# Access Compliance Report

### (Curb Ramps)

Intersection ID: N/A	Main Street: MONROE_RD	Cross Street: BUFORD_AV	Location: SW
ADA ID: A530B2808512	Ramp Type: Directional2	Initial Pass/Fail: Fail	Overall Compliance: No
		Severity Score: 12.5

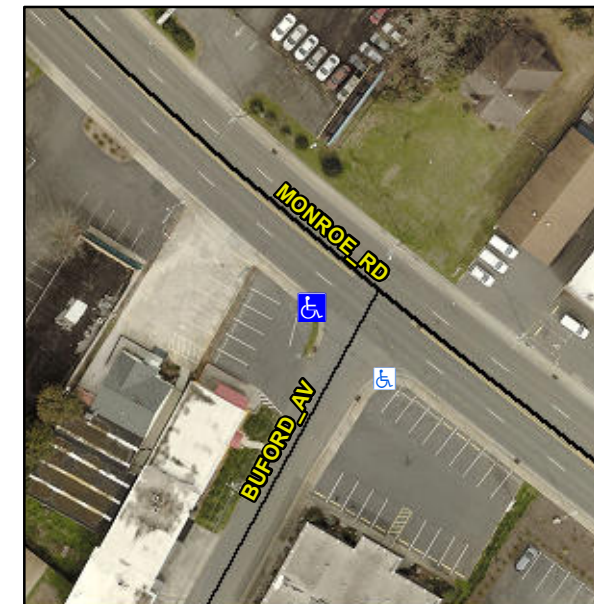
**R304.2.2**

Compliance	Description	Data	Compliance	Description	Data
N/A	Ramp Length (in)	49.0	N/A	Grade Break?	N/A
Yes	Ramp Width (in)	49.0	N/A	Grade Break Slope (%)	0.0
No	Ramp Slope (%)	11.6	N/A	Grade Break XSlope (%)	0.0
Yes	Ramp XSlope (%)	1.5			
N/A	Flare Type LT	N/A	N/A	Flare Type RT	N/A
N/A	Flare Slope LT (%)	N/A	N/A	Flare Slope RT (%)	0.0
N/A	Flare Traversable LT?	N/A	N/A	Flare Traversable RT?	N/A
N/A	Landing Length (in)	0.0	N/A	DWS Provided?	N/A
N/A	Landing Width (in)	0.0	N/A	DWS Contrast?	N/A
N/A	Landing Slope (%)	0.0	N/A	DWS Length (in)	N/A
N/A	Landing X Slope (%)	0.0	N/A	DWS Full Width?	N/A
N/A	Landing Curb? (Y/N)	N/A	N/A	DWS Offset LT (in)	N/A
N/A	Shared Landing?	N/A	N/A	DWS Offset RT (in)	N/A
N/A	Gutter Ponding?	0.0	N/A	Gutter Slope (%)	N/A
N/A	Gutter Lip Ht (in)	0.0	N/A	Gutter X Slope (%)	N/A
N/A	Painted X Walk1?	No		Road Slope (%)	3.2
	X Walk 1 Direction	To SE		Road X Slope (%)	1.9
	X Walk 1 Width (in)	N/A		Clear Space?	N/A

**Remove & Replace Entire Ramp.**
